PERMIT

Permit No. 825-77 Issued 9/9/77 date
 Job Location 1058 N. Sheffield Ave. address
 Lot n/a sub div or legal discript
 Issued By Ronald D. Sonnenberg building official
 Owner Keith Buehrer 592-4332 tel.
 Address 1058 N. Sheffield Ave.
 Agent Self Same tel.
 Address Same
 Description of Use Brick & Aluminum on front of house.
 Residential XXX(10) no. dwelling units
 Commercial _____ Industrial _____
 New _____ Add'n. _____ Alter _____ Remodel XX
 Mixed Occupancy _____
 Change of Occupancy _____
 Estimated Cost \$400.00

RESIDENTIAL PLAN CORRECTION SHEET

ADDENDUM to Permit No. 825-77

FRONT VIEW

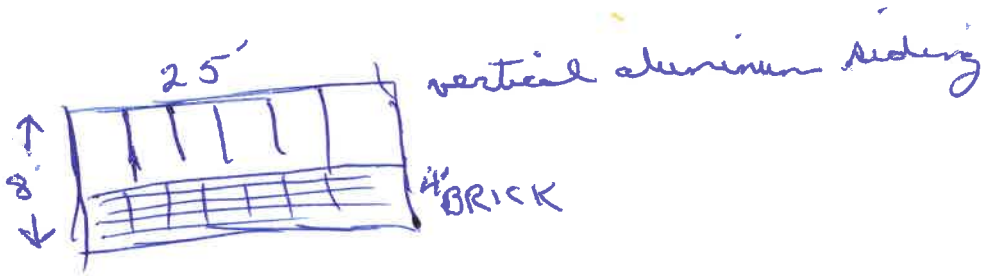
ADDITIONAL CORRECTIONS: ATTACH MASONRY VENEER TO SUPPORTING WALL WITH METAL TIES. VENEER SHALL BE SUPPORTED ON FOOTER OR FOUNDATION IN AN APPROVED MANNER.
